FOR
LOT 4 OF CHALICE ACRES SUBDIVISION (LOT AREA: 86,261 SF)
LOCATED IN THE NE 1/4 OF SECTION 22, T1N, R26E, P.M.M.,
IN THE CITY OF BILLINGS, YELLOWSTONE COUNTY, MONTANA
PREPARED TO SHOW PROPOSED DEVELOPMENT
OF 4-NINE PLEX RESIDENTIAL APARTMENT BUILDINGS,
IBC OCCUPANCY CLASSIFICATION RESIDENTIAL GROUP R-2

Re: City Special Review #924, Project # 15-18:
Submittal of Information for Consideration by Zoning Commission

1. Revised Site Plan and Sections, sheet 1 of 4 (2 copies plotted at 24"x36")
2. Revised Site Plan and Sections, sheet 1 of 4 (2 copies plotted at 11"x17")
3. Revised Stormwater Drainage Plan and Details, sheet 2 of 4 (2 copies plotted at 11"x17")
4. New Site Plan with Landscape and Exterior Lighting Concept, sheet 1-A (2 copies plotted at 11"x17")

SITE PLAN
SCALE: 1" = 40'

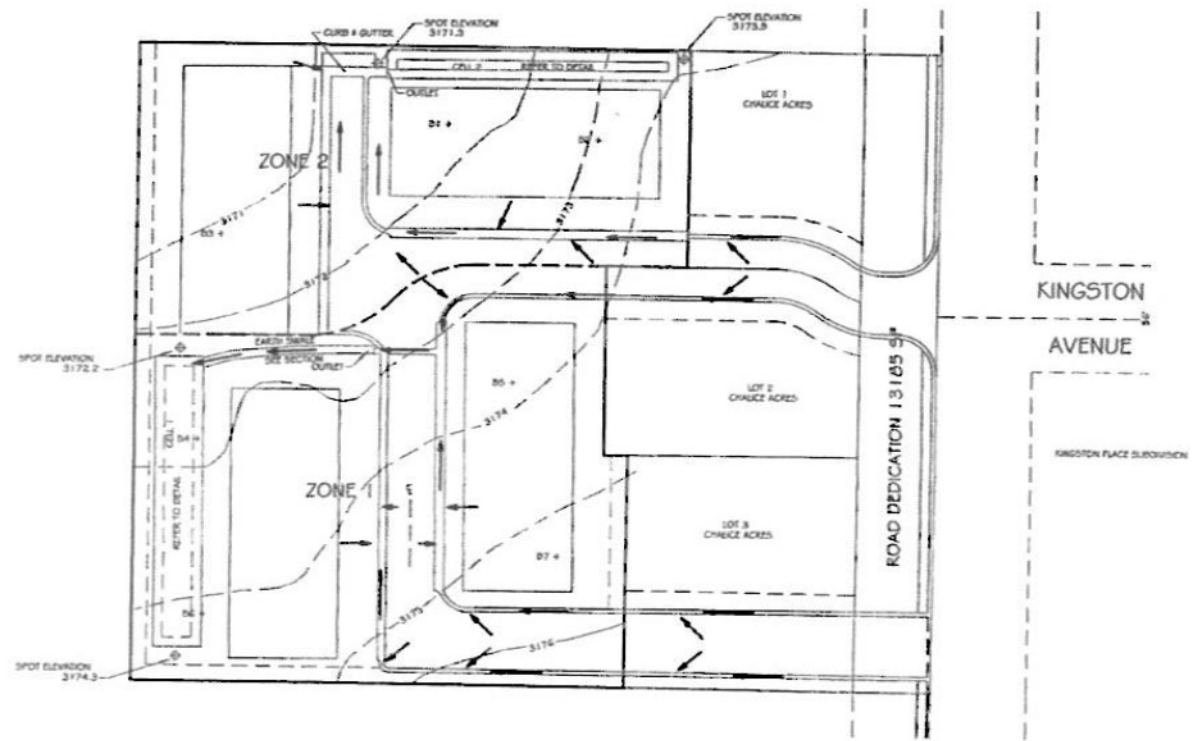
Revisions to the layout previously considered include:

The height of each building will not exceed 24 ft-9inches above the finished first floor slab-on-grade.

Designated Parking Spaces: A total of 77 spaces for residents and guests will be provided as follows: 36 private single car garages plus space for one car in front of 30 garage doors plus 11 parallel parking spaces along the curb of the driveway loop. This averages out to 2.1 vehicle spaces per dwelling.

The parking spaces in front of each garage door were created by moving Buildings 1, 2 and 3, and the south 1/3 of Bldg 4 an additional 6 ft from the curb. The north portion of Bldg 4 could not be moved due to the zoning required setback from west property boundary.

Additional Improvements: Sight obscuring fencing will be constructed adjacent to residential properties along the east and south boundaries; common solid waste collection enclosure located on north boundary between Bldgs 1 & 2; central post office boxes enclosure on concrete pad installed north of Bldg 4; and concrete sidewalk to access Bench Blvd along south boundary will require approval by Northwestern Energy due to their private utility easement along this boundary.

WITH LANDSCAPE AND EXTERIOR LIGHT

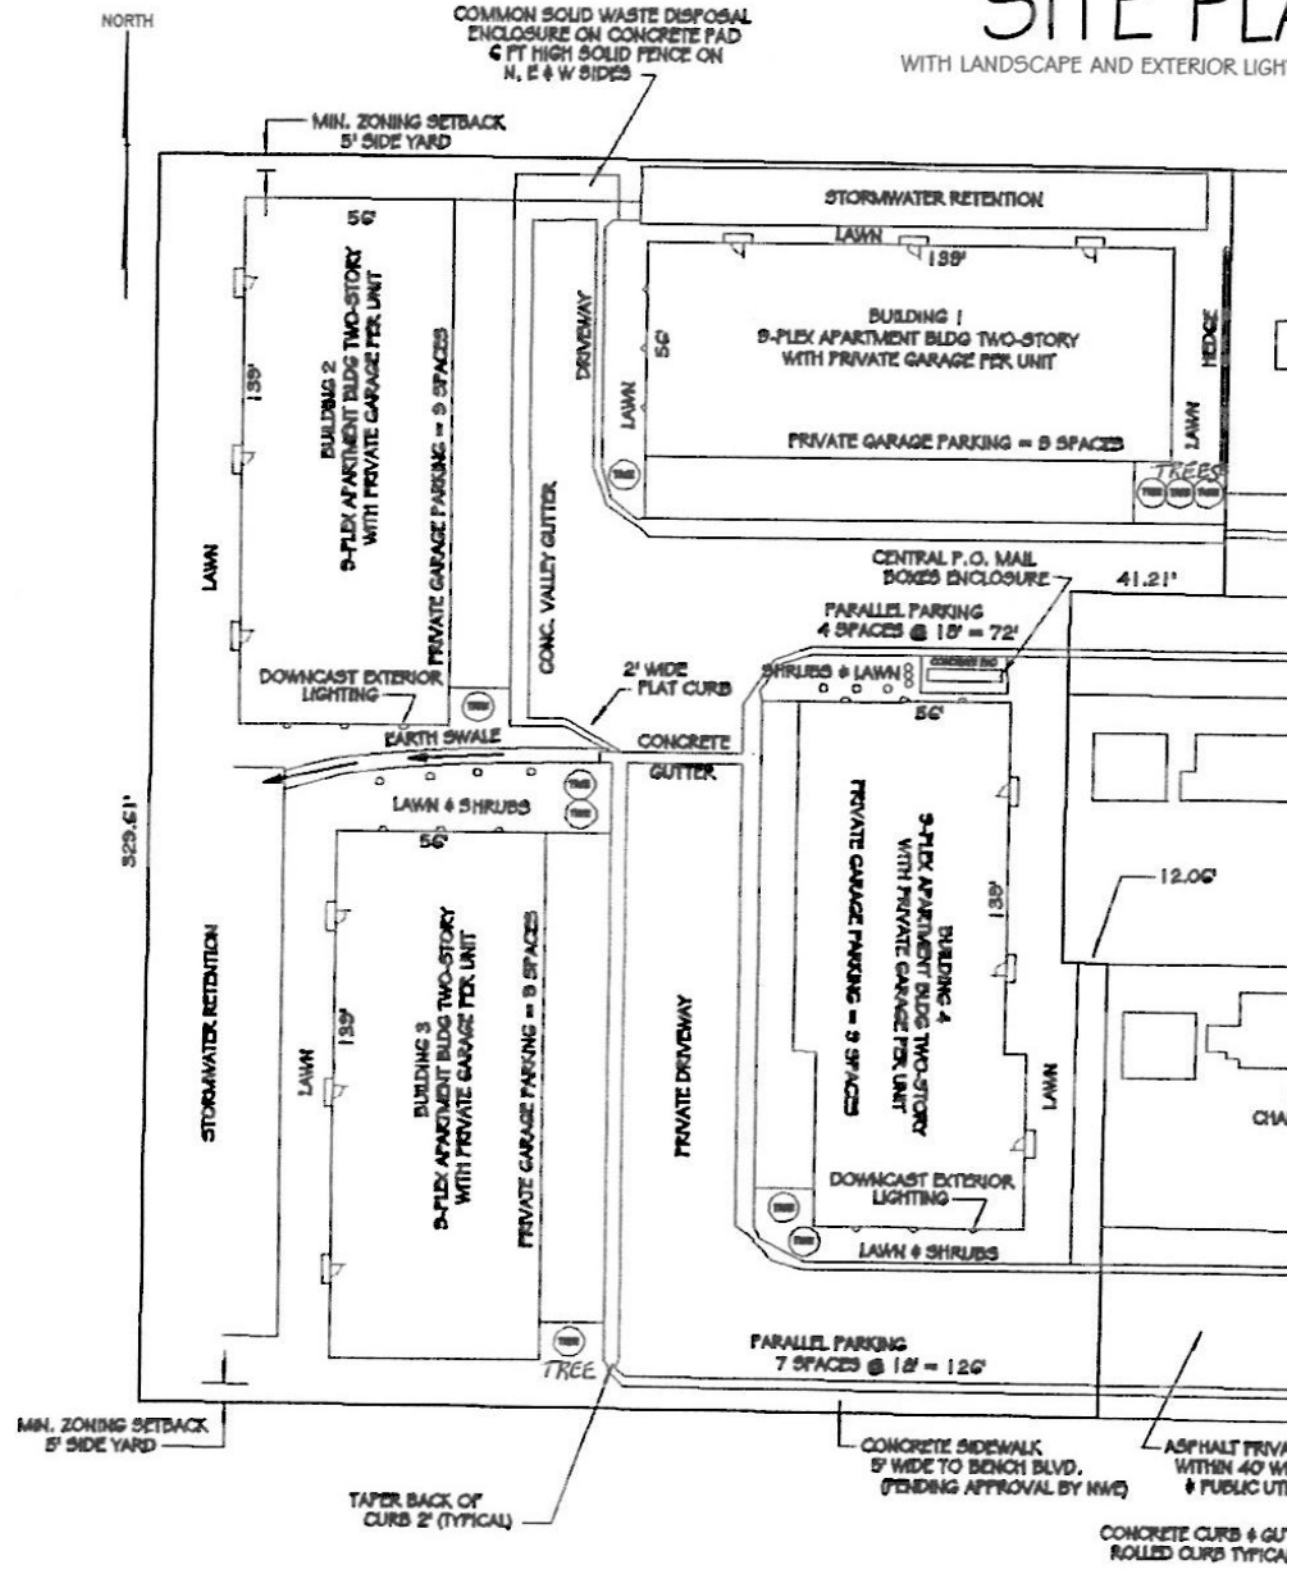
Landscape Plan and lighting concept: The general layout of lawn, shrubs and trees has been depicted on the enlarged site plan. A total of 10 trees have been shown. Down-cast luminaires will be provided over garage doors and on select ends of buildings to provide ambient light for safety of pedestrians at night while minimizing horizontal spread of light beyond this development.
